MEMORANDUM

SUBJECT: Basic American Foods-Rexburg Wastewater Reuse Permit Application Review -- LA-000040-02 (Industrial Wastewater Facility)

Total Fe Ground Water Concentration 1994-2006- Plant Farm

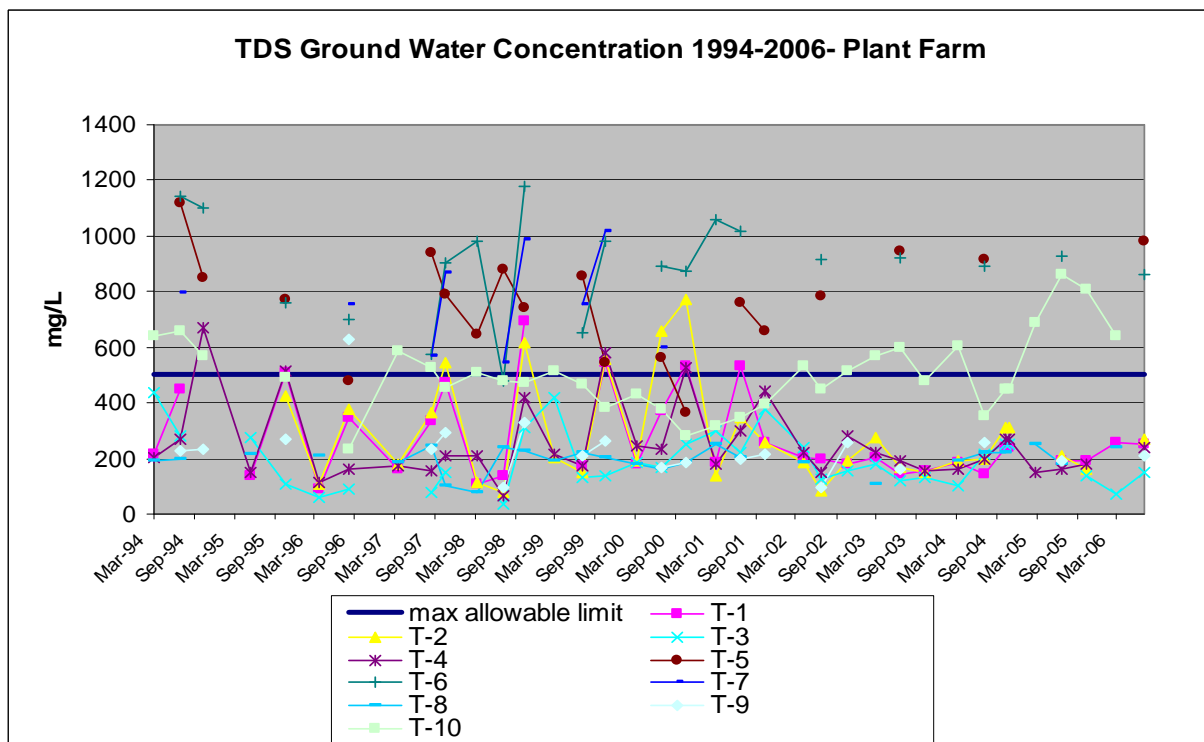
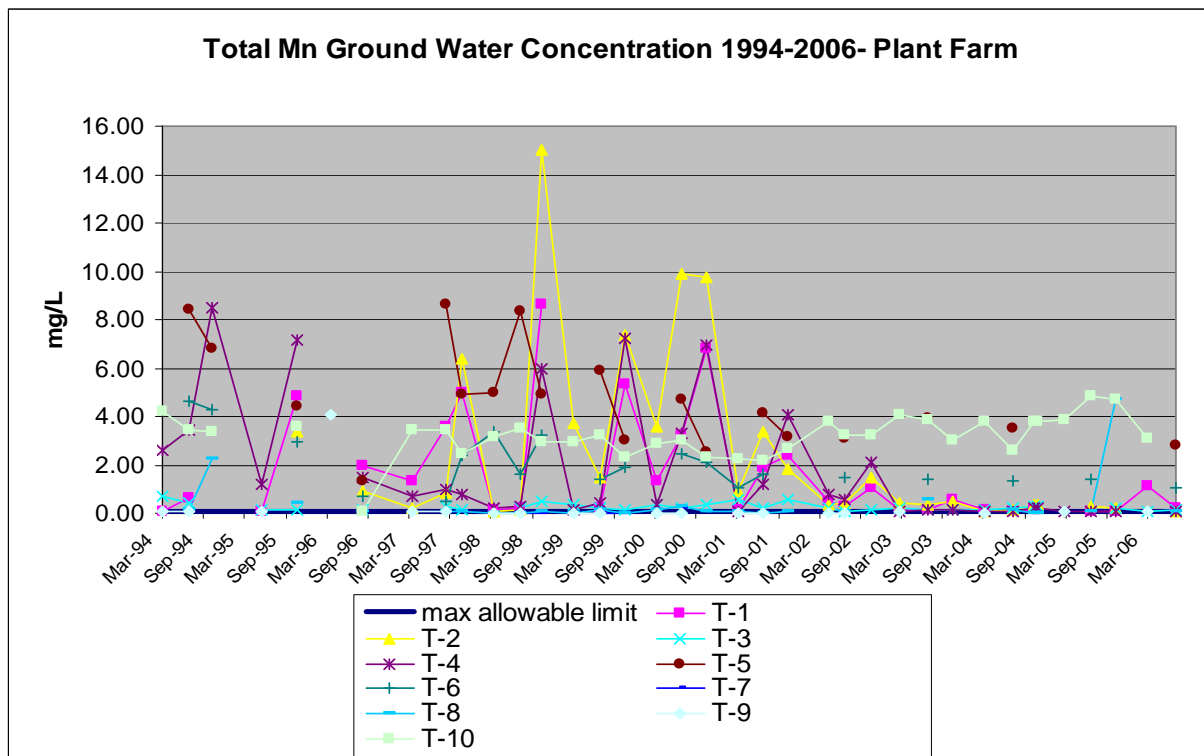
As evidenced by the graphs above, a number of the facility's wells have been in exceedance of the ground water quality standard for total dissolved solids (TDS) on a fairly regular basis and the majority of the wells are consistently above the standards for both total iron and total manganese. The Ground Water Quality Rule (IDAPA 58.01.11) gives the secondary constituent standards for iron and manganese as 0.3 milligrams per liter (mg/L) and 0.05 mg/L, respectively. Many of the samplings have

exceeded these standards by a fairly significant amount, with results ranging from 1.00 mg/L to 5.00 mg/L and well above for both constituents. The facility has attributed the elevated levels to historical contamination at the site and has also performed a number of dissolved samplings to determine the extent to which turbidity may contribute to these levels. Please see Appendix 1, Table 1 for a comparison of the total and dissolved results for both constituents.

As previously discussed, and demonstrated in Table 1, exceedance of the ground water quality standards for total iron and manganese is the rule rather than the exception, even for the facility's up-gradient wells. However, as illustrated in the table, it also appears as if a fair amount of the elevated iron levels may be due in part to a certain amount of turbidity or possibly the wells' steel casings, given the fact that the bulk of the dissolved iron samplings come in below the secondary standard, with the notable exceptions of wells T-6 and T-10. At the same time, there appears to be little variance between the total and dissolved sampling for manganese, indicating that not only do these wells exceed the ground water standard but also that turbidity plays little part in this exceedance, with the exception of the up-gradient well T-8.

Generally, the presence of high concentrations of iron and manganese in monitoring wells indicates anoxic conditions in the soil which have lead to the reduction of these minerals to their soluble and mobile forms, thereby freeing them to leach into the ground water at the site (DEQ, 2006). In this case the anoxic conditions are most likely due to the consistently high hydraulic loading rates which the fields at the Plant Farm have experienced during the non-growing season, causing the soils to be often waterlogged and therefore oxygen-depleted. For further discussion of historic hydraulic loading rates and permit recommendations see Section 4.5.2.3.

Figure 2. Management Unit Configurations and Well Locations—Salem Farm

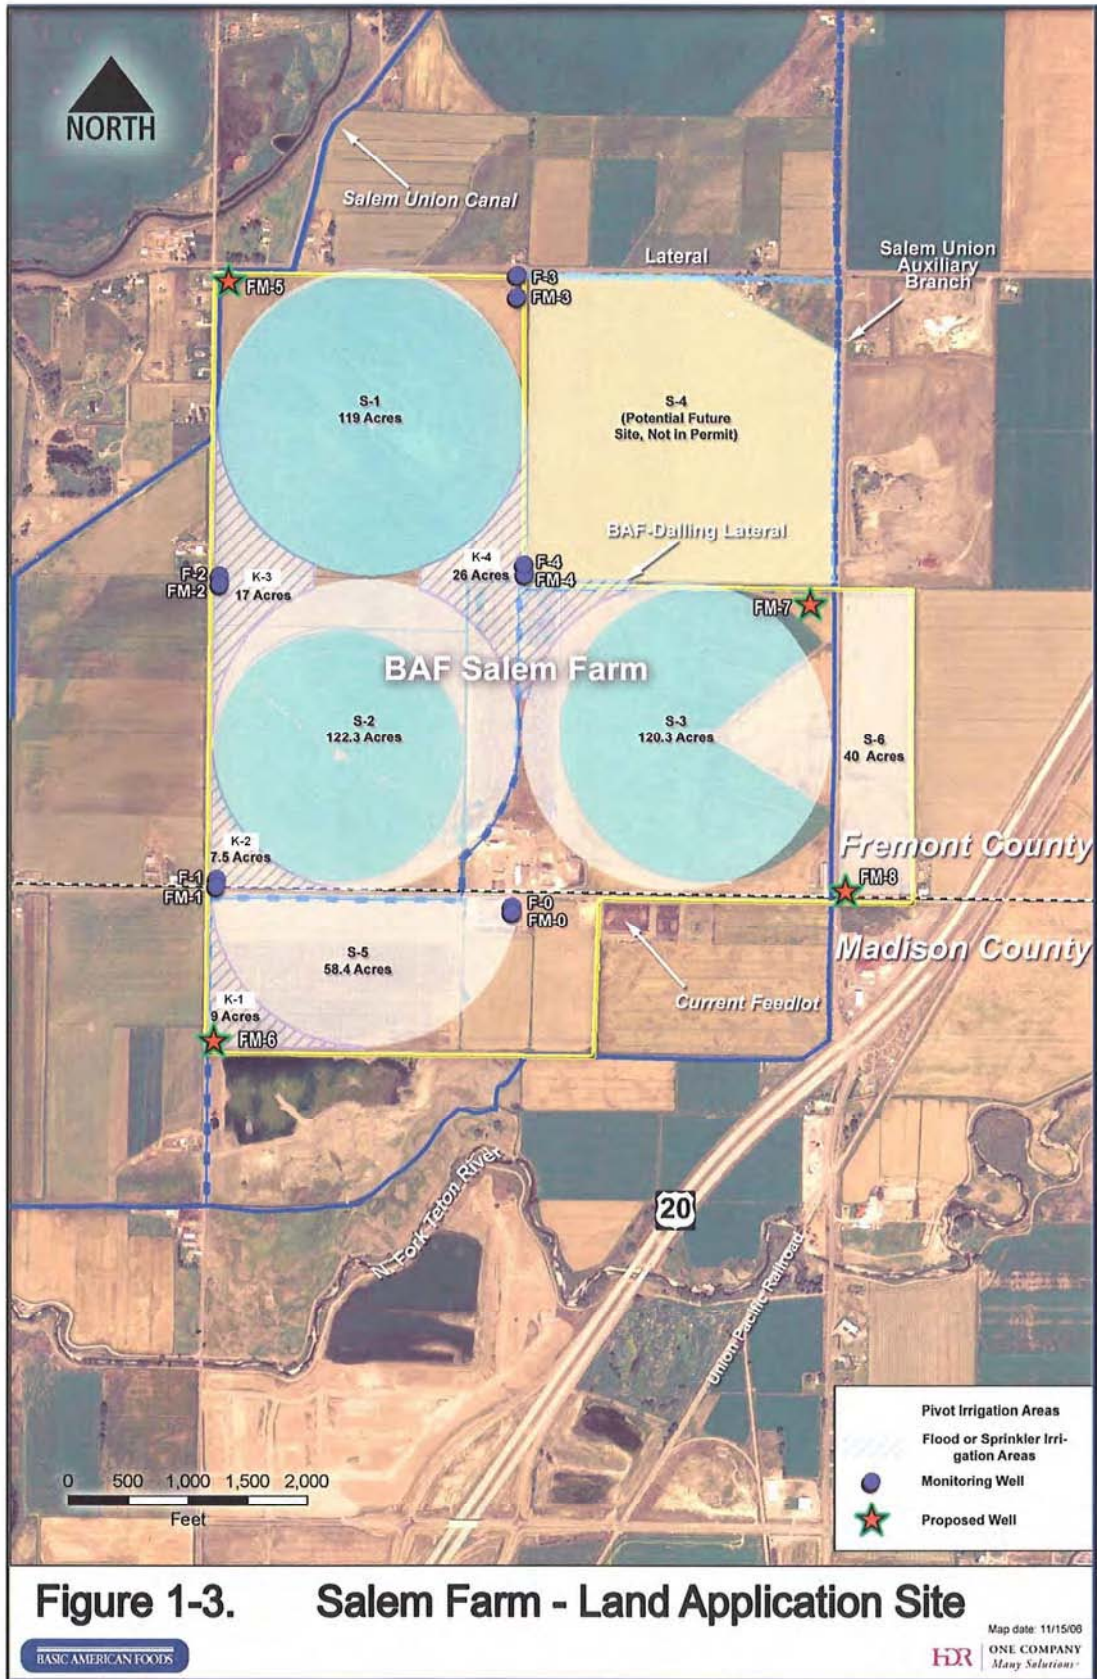
The Salem Farm has a network of ten monitoring wells, five completed to various depths consistent with the regional aquifer and five screened in the shallow alluvial aquifer. The F-series, or deep wells, are sealed between 45 to 65 feet bgs and were installed in 1987. The FM-series, or shallow wells, are 25 feet deep, screened for the lower 10 feet, and were installed adjacent to the F-series wells in 1989 (See

Appendix 2, Figure 2). The hydrographs for these paired wells indicated water level fluctuations occur simultaneously through the entire saturated thickness of the alluvial aquifer indicating a hydraulic connection the vertical direction. Generally, regional ground water flow in the area is to the west and southwest with recharge surface water moving in part vertically downward and in part laterally, discharging to down-gradient streams such as the North Fork of the Teton River. However, due to localized mounding, ground water flow beneath the site often does not coincide with expected flow patterns (CES, 1991). Flow measured by CES in 1991 in the FM series wells appear to be in a variety of directions, predominately trending towards well FM-4; a pattern which is attributed to influence from irrigation wells and canals, and recharge from surrounding flood irrigation towards areas of non-flood irrigation. This flow pattern occurs again in HDR's November 2004 water table map, however, it seems unlikely that ground water flow would be influenced by irrigation practices at that time of year. These flow patterns are unusual enough to warrant a resurvey of the site's wells. It is recommended that the facility have these wells, along with the aforementioned T-series wells at the Plant Farm, resurveyed by an Idaho licensed land surveyor. For the full text of this compliance activity see CA-040-06 in Section E of the permit.

As a result of the number of uncertainties which still exist with regard to the ground water at the Salem Farm, it is recommended that a Ground Water Characterization Plan, CA-040-05 in the permit, be implemented which includes the following: 1) FM Series wells be recompleted, or new wells drilled as necessary, so the wells yield samples throughout the year and be sampled as close to the water table as possible, 2) proposed wells FM-5, FM-6, FM-7, and FM-8 be completed in a similar manner, 3) plans and specifications for both the proposed wells and the updates to the current FM series wells be submitted to DEQ for approval prior to construction. For the full text of this compliance activity see CA-040-07 in Section E of the permit.
